UNITED STATES PATENT AND TRADEMARK OFFICE

10/561,331

Office Action Summary	Application No. 10/561,331	Applicant(s) BAILEY, MARSHALL GRAHAM	
	Examiner BENJAMIN KURTZ	Art Unit 1797

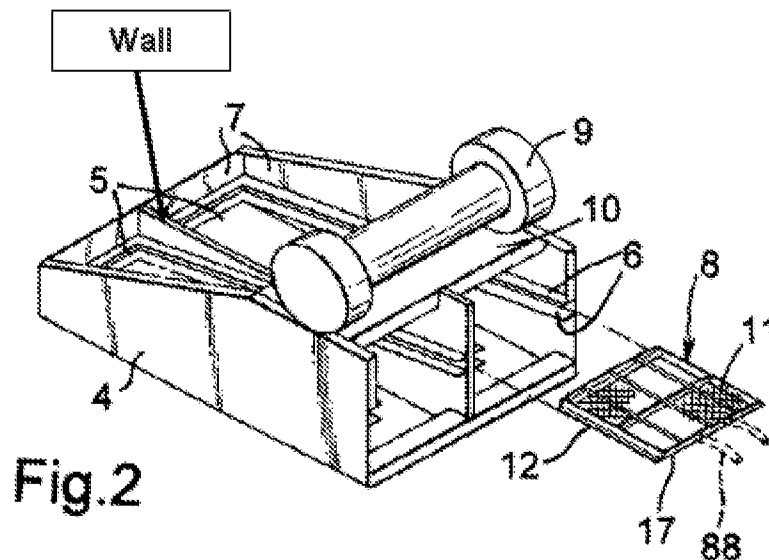
Claims 13, 16 and 17, Wiseman teaches the basket of claim 9 but does not teach the flow distributor including a wall. WO teaches a basket comprising a flow distributor comprising a wall/lateral divider (see below) formed and arranged to define a plurality of laterally adjacent flow pathways (fig. 2, below). The claim would have been obvious because all the claimed elements were known in the prior art and one skilled in the art could have combined the elements by known methods with no change in their respective functions and the combination would have yielded predictable results to one of ordinary skill in the art at the time of the invention, *KSR International Co. v. Teleflex Inc.*, 82 USPQ2d 1385 (2007).

Providing a lateral divider (wall, above) is known in the art as shown by WO. The claim would have been obvious because all the claimed elements were known in the prior art and one skilled in the art could have combined the elements by known methods with no change in their respective functions and the combination would have yielded predictable results to one of ordinary skill in the art at the time of the invention, *KSR International Co. v. Teleflex Inc.*, 82 USPQ2d 1385 (2007).
